Reservoir Embankment changes & inclusion of an offshore valve tower

Planning references: HBC APP/24/00311

Havant Thicket Reservoir: Application for Reserved Matters relating to Phase 3 – Main Embankment; Changes in relation to siting, scale, external appearance and landscaping of the reservoir embankments, pursuant to condition 2. New layout is based on the revised Section 73 application layout, which includes the offshore valve tower.

Section 73 application to vary Conditions 2 (pre commencement condition) & 3 (approved plans) for proposed changes to the size & alignment of the main reservoir embankment and related infrastructure including; a new offshore valve tower, changes to the Avenue Staircase & western viewpoint

G8. Proposed Culvert & Valve Tower Layout Drg.0013

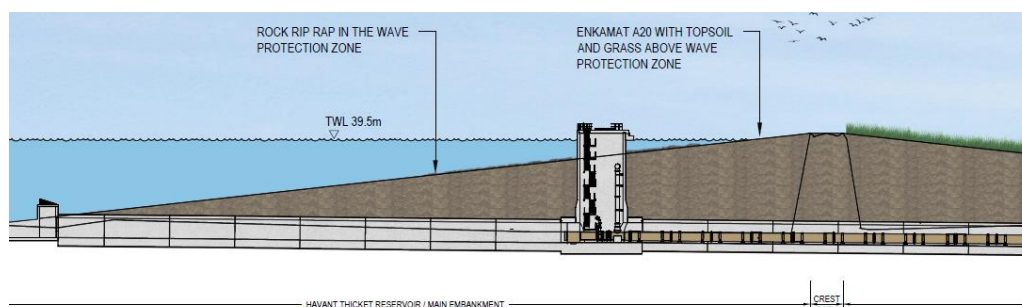
- a) The detail of the Upper Intake and what it will look like is unclear. A structure is shown protruding from the left side of the tower section on drg.0015, which is likely to be the Upper Intake but it is not labelled. The cross section on drg.0015 for Floor E & on drg. 0020 Section A suggest that the Upper Intake is a concrete structure protruding a significant distance from the tower, some of which is buried in the embankment slope, but elements of the structure are likely to be clearly visible from both the new western and Avenue viewpoints and other vantage points along the crest path when the reservoir is in drawdown?

- b) Top water level, seasonal normal summer water level, drought drawdown level and maintenance drawdown levels are not shown/ labelled on the sections included on drg. 0015 or 0020. This critical information should be shown on revised drawings as it is important to understanding what elements of the offshore valve tower will be visible during various scenarios, and how often this will occur. (See also ‘f’ below)

- d) A rail is shown at the top of the valve tower on Section E(drg.0020) which rises above the stated height of the tower of 41.1m (Planning Statement, para 2.11 & ES Addendum page 61 para 10.8.6 of the Landscape & Visual Impact Chapter both refer to assessing a height for the tower of 41.1m). Yet the safety rail rises to a height of 1.2m above that and will add significantly to the visibility of the valve tower, which itself is already 0.6m above the crest path level. With the rail included the tower structure will rise to 1.8m above the crest path level.

- The presence of the safety rail needs to be fully considered as part of the visual impact assessment.
 - On drg.0020, Section A shows the safety rail on either side of the tower, but not on the one face viewed. Presumably the rail is missing from this side of the tower to allow access via boat, as mentioned in the Planning Statement. If access is possible via a boat for operational staff, then there is also a risk of access by members of the public/ children who will see accessing the tower as a challenge, especially as a feature they would want to dive/ jump from.

- f) On drg. 0015 there is a solid line shown to the left of the tower at a level of 40.75m, it is not clear what this line is intended to represent as it is not labelled? It is probably just a level marker line, but other level markers lower down the structure are shown as a dashed line. I am concerned that some people may think that this solid line represents the top water level of the reservoir which it does not, as the top water level is lower at 39.5m. With the Planning Statement at Section 2.11 confirming that 1.5m of the tower protrudes above top water level when full and up to 3.5m is exposed seasonally, with the water level dropping 12m to the Lower Intake in a drought scenario. As stated in 'b' above the depth of water under different operating scenarios must be added to the drawings to aid understanding by the public,

It is clear from Drawing 0013 that there is only a small gap between the crane platform extending north from the crest road (but not labelled), to the valve tower. Concerns about public safety and visibility could be addressed by infilling the gap to create a promontory that would ensure that the valve tower is not located in an offshore position.

The LPA need to request revised drawings showing the water level around the tower under different operational scenarios to ensure they fully understand what of the valve tower features and how much of the tower will be visible in different operating scenarios, before making any decision if they are minded to give consent.
